Parking Lot District Service Facility, Mandatory Referral, MR2016006

Completed: 05/26/20216

OVERALL SITE
 DEVELOPMENT
 PLAN

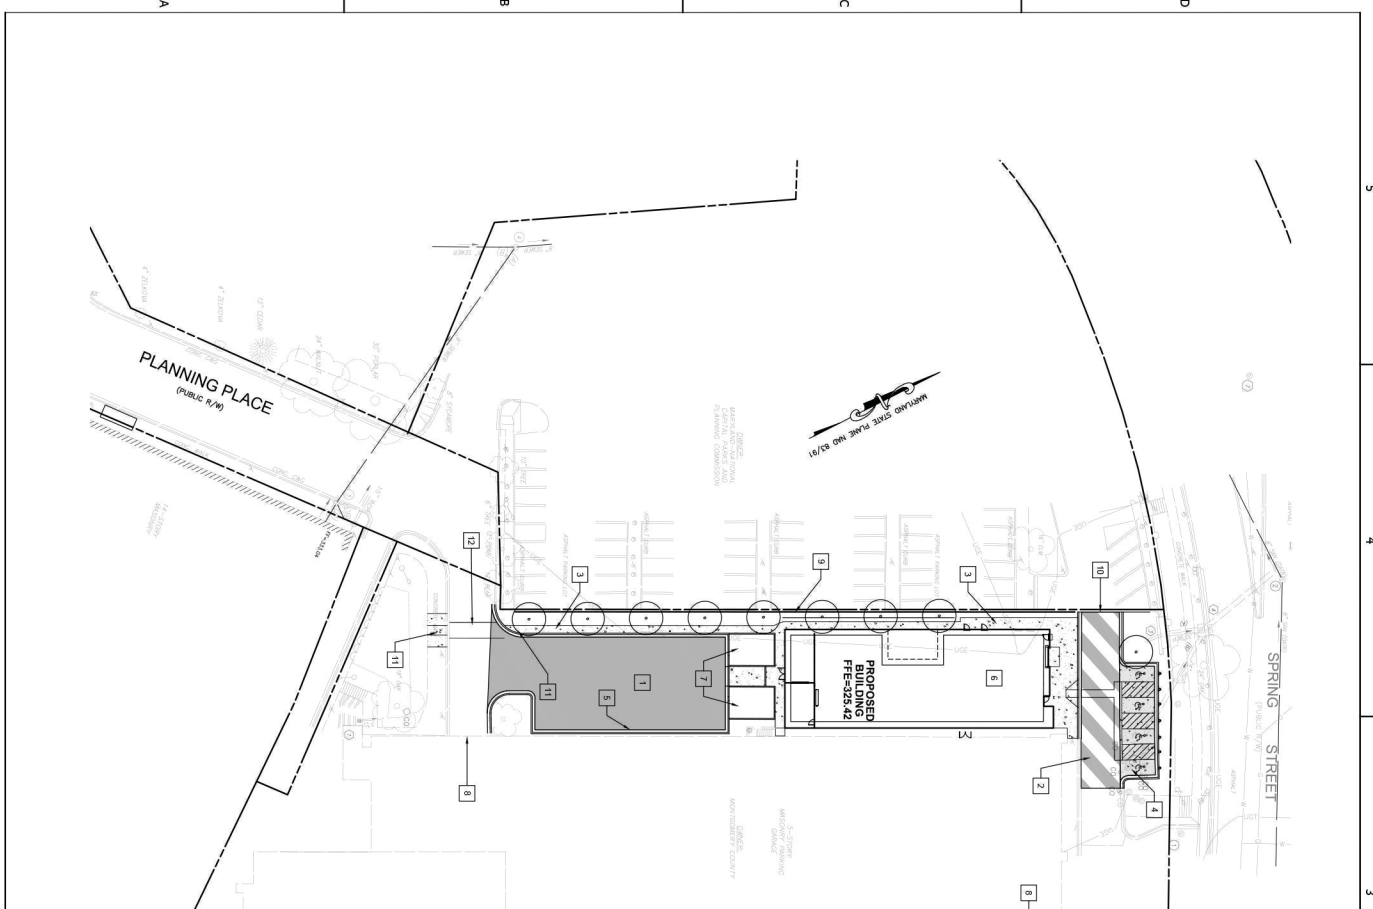
3. The “Overall Site Development Plan (SDP-1)” labels an area near the middle of the project (on MNCPPC property) as “One-Way” with a directional arrow toward Spring Street.
 - a. This label is misleading and should be revised (or removed). The label does not correspond to a drive aisle associated with the subject site and is placed perpendicular to an existing drive aisle on the MNCPPC site.

1. Proposed green roof in keynotes is incorrectly spelled.
Applicant Response: Keynote misspelling will be revised with resubmission.

Applicant Response: This is an errant label left over from a previous design iteration, it will be removed.
